## **ENGINEERING CHANGE NOTICE**

Date: 99,	03.25			ECN#: 179
				1/8
Project No.:	D350-636	Created By:		Checked By:
Project Name:	350 Skidtubes	Approved By: (proj. manager)	A T	Approved By: (management if req'd)

## DART ENGINEERING ORDER

TO AMEND DWG: D2742 REV. B

DI	DS DS	ORAWN BY	DART AEROSPACE LTD HAWKESBURY, ONTARIO, CANADA			
CI	HECKED DS	APPROVED LE	DEO 9147	REV. A		
D/	99. 03.	1 1	TITLE  BLADE FITTING CHANGES	SCALE NTS		
1	A 99.03.25		NEW ISSUE (N/C 183)

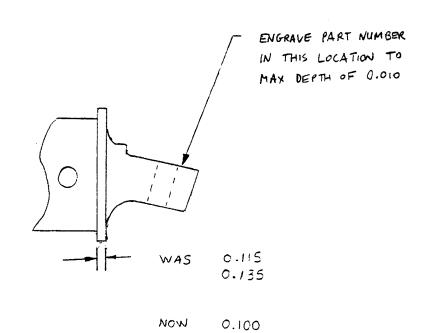
- ammends D2742 Rev B
- adds part no. engraving detail
- ammends collar thickness tolerance

0.135

- Parts should be checked to DEO 9147
- IPP does not have to be updated.
- Program has already been updated, for part numbering engraving
